Product Change Notification

1. ECR #: 164011
Notification #: 331

3. Series:
• BCS - BOX CONNECTOR SOCKET STRIP

Before and after image of body component BCH-XX-D

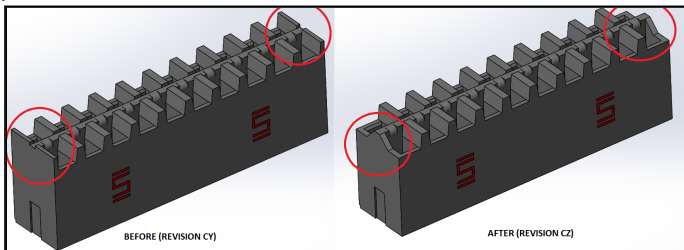
5. Description of Change:
Reduction in size of end-walls of the plastic insulator housing. This will be a rolling change (inventory at current revision will be exhausted prior to implementation).

6. Method of Identifying Change
This change is visible with the unaided eye. New SSM-1XX-XXX-DH-XX-XX-XX-XX will have reduced plastic volume on the end walls and a new chamfer added.

7. Reason for Change:
This change eliminates non-functional thin plastic that has a history of breaking.

8. Impact of Change on Form, Fit, or Function:
• Form - The change will be visible with the unaided eye. There are no anticipated changes to fit or function.
